PCN

## **Middle frequency welding for EM series of EPCOS 2-electrode arresters**

## Product / Process Change Notification

## Comparison between current and MF welding design

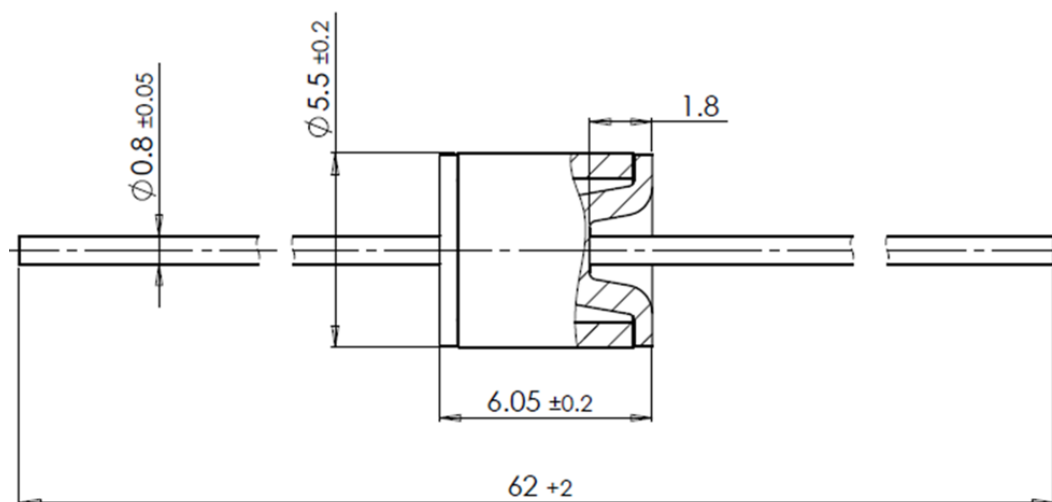
Middle frequency (MF) welding technology has now been qualified and internally approved for the EM series of EPCOS 2-electrode surge arresters manufactured in Xiaogan, China. Copper (Cu) will be used as the base electrode material instead of iron-nickel (FeNi). The dimensions of the components remain unchanged with the exception of very minor modifications to the calotte of the outer electrodes. The plant in Xiaogan already introduced this MF welding technique in 2010 for other products.

Drawing of current welding design:

Drawing of new MF welding design:
